# NRCan's Final Comments on the Proposal for In-Pit Tailings Disposal at the Meadowbank Mine

Natural Resources Canada

**Submission to the Nunavut Water Board**

**September 21, 2018**

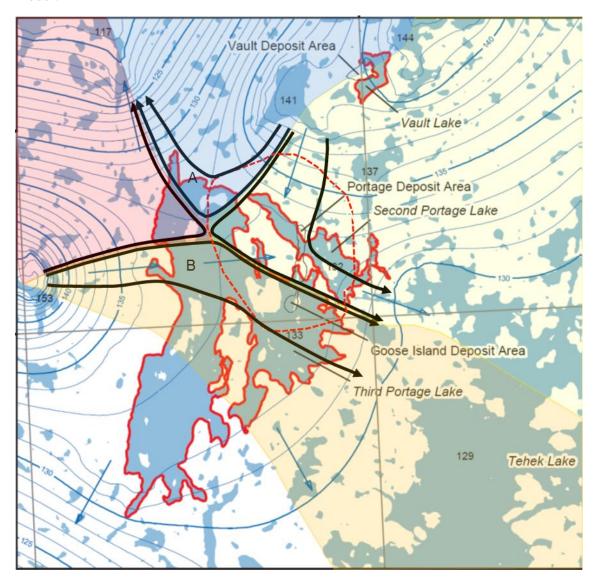
Groundwater flowlines were superimposed on the Golder (2004) sub-permafrost groundwater equipotential contours to indicate the approximate groundwater flowpaths in relation to the SNC-Lavalin (2017a; 2018e) model boundaries (Fig. 1). The flowpaths are challenging to interpret given the intersection of four sub-permafrost groundwater flow systems at the edge of the SNC-Lavalin modelling domain (Turn Lake to Tehek Lake, Turn Lake to lake with elevation 117 m, lake with elevation 153 m to Lake Tehek, and lake with elevation 153 m to lake with elevation 117 m (Fig. 1)). Three different groundwater flow systems overlap the SNC-Lavalin modelling domain; the Portage A and E pits are located in one flow system (Turn Lake to Lake Tehek), whereas the Goose Pit lies within another (lake with elevation 153 m to Lake Tehek). The SNC-Lavalin models (2017a; 2018e) assume there is one groundwater flow system originating at the NW model boundary and discharging beneath the Second Portage Lake. The proposed boundary conditions for the version 3 model (AEM, 2018d) also assumes a single groundwater flow system originating along the north and NE boundaries of the model and discharging to the SE boundary of the model.

As noted in the previous section, the Golder (2004) sub-permafrost groundwater equipotential contours indicate the intersection of four sub-permafrost groundwater flow systems (Fig. 1) along the edge of the SNC-Lavalin modelling domain. Three different groundwater flow systems overlap the SNC-Lavalin modelling domain; the Portage A and E pits are located in one flow system, whereas the Goose Pit lies within another. NRCan's recommendations for boundary conditions attempt to maintain these different flow systems within the established modelling domain. The current (SNC-Lavalin, 2017a, 2018e) and proposed boundary conditions (AEM, 2018d) result in one flow system with groundwater flow paths and directions that differ in important ways from the Golder (2004) model. NRCan's suggested boundary conditions for sub-permafrost groundwater attempt to maintain the regional flow implied by the Golder (2004) model and are explained below for each segment of the SNC-Lavalin model boundary (labelled A to K in Figure 2).

Segment A-B) (flowtube A in Fig. 1) shows that there is outflow along this segment of the model boundary to the NW as discussed by Golder (2004). NRCan recommends a constant head of 133.6 m (the 133 m contour plus the 0.6 m correction discussed above).

Segment C-D) (flowtube B in Fig. 1) shows that there is inflow to the model from the west along this boundary. This inflow influences the regional groundwater flowpaths as it flows to the SE and deflects flow from the north (Turn Lake) towards the east (influencing flowpaths around the pits) (Fig. 1). It suggests that the source of water flowing beneath the Goose Pit may not originate from the Turn Lake area, but rather from the lake with an elevation of 153 m (Fig. 1). Setting this boundary is challenging. Assigning a head of 133.6 m (at C) to 133.2 m (at D) would be consistent with the Golder (2004) model results. However, these values may not give the desired result, as it could produce outflow along this segment rather than inflow as suggested by the Golder (2004) model (see Fig. 1). NRCan recommends some testing of the boundary conditions along segment C-D in order to produce groundwater inflow along this model segment.

Segment E-F) Figure 1 demonstrates that the Golder (2004) model indicates groundwater outflow along this segment. NRCan recommends a constant head boundary condition in the subpermafrost groundwater varying from 132.9 m at E (approx. 132.3 + 0.6 m) to 132.7 m at F (approximately 0.2 m lower than Second Portage Lake, see segment F-G).
